18-025ARB-MPR – MIDWEST GAS SIGN

A Master Sign Plan (MSP) for a ground sign for an existing tenant space.

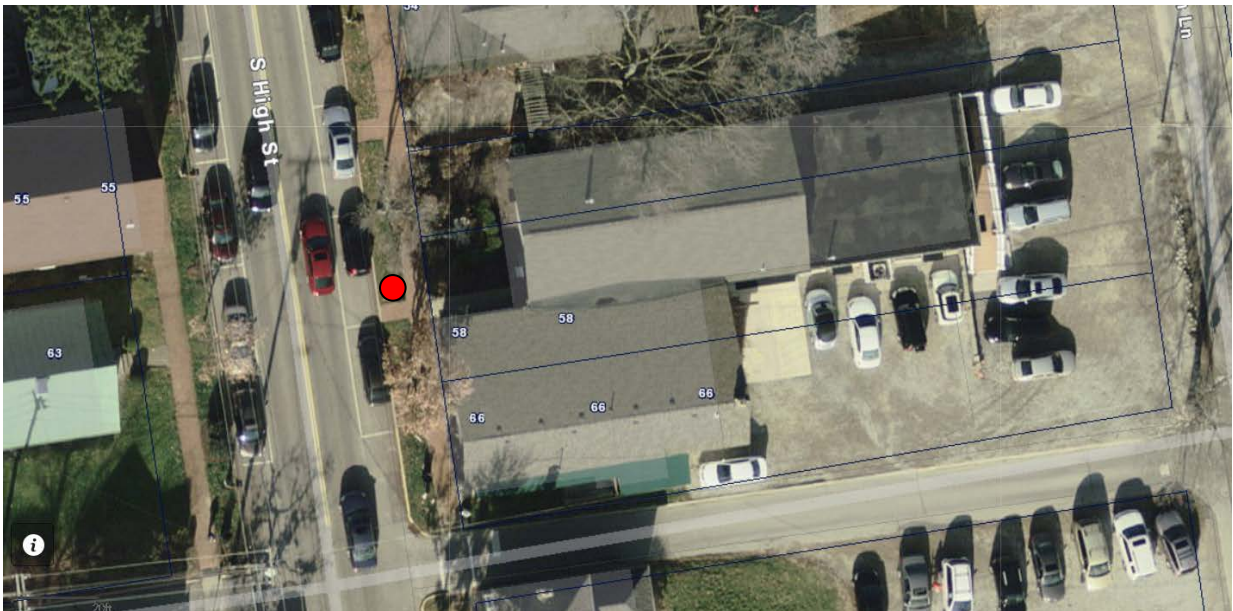
Code permits a maximum sign size of 8 square feet and a maximum height of 6 feet for ground signs. The proposed panel is approximately three square feet, which matches the size of the existing panel making the overall sign area is six square feet. The height is unchanged, but requires verification it is under the six-foot limitation.

The proposed sign panel is a double-faced, MDO (Medium Density Overlay) plywood sign, which is not a permitted material. The sign will need to be revised to incorporate an approved material of High Density Urethane (HDU), cedar, redwood, treated lumber, and equivalent materials, as required by Code.

Code requires signs to be limited to three colors. The proposed sign includes two colors: black chromatic for the background and white for the routed areas and letters, which meet Code and match the existing sign.

As noted above, the sign location was approved in 1995 and is considered non-conforming, which means it cannot be expanded in its current location and will need to be removed from the right-of-way. Code requires ground signs to be located eight feet from the right-of-way. Given the location and design of the existing building, Planning and Engineering recommend relocating the sign approximately three feet to the east of the sidewalk (not the entire eight feet from the right-of-way required by Code). A MSP is required to allow the reduced setback.

- 1) That the applicant relocate the sign to approximately three feet to the east side of the sidewalk to ensure the sign post, arm and panels do not extend into the sidewalk.
- 2) That the applicant use a permitted wood material for the sign background and lettering (HDU, cedar, redwood, treated lumber, or equivalent material).
- 3) That the applicant verify the height of the sign does not exceed six feet.
